ساخت موقعیت چاه، تاسیسات سرچاهی و خطوط جریانی مربوط به موقعیت W018S

PDINS MODEL REVIEW REPORT (60%) - W0185									
پروژه	بسته کاری	صادر کننده	تسهيلات	رشته	نوع مدرك	سريال	نسخه		
BK	W018S	PEDCO	110	PI	RT	0001	D03

PDMS MODEL REVIEW REPORT (60%) - W018S

نگهداشت و افزایش تولید میدان نفتی بینک

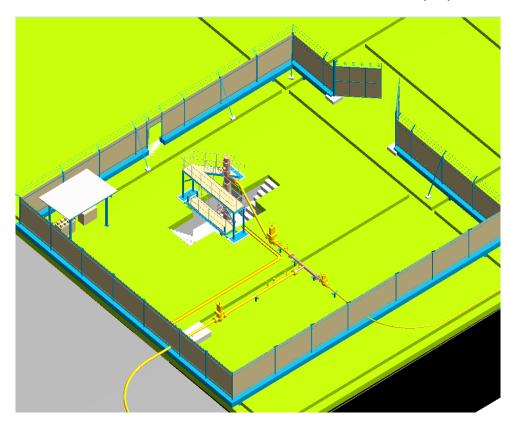
6.1 The location of the doors should be modified based on the sample provided.
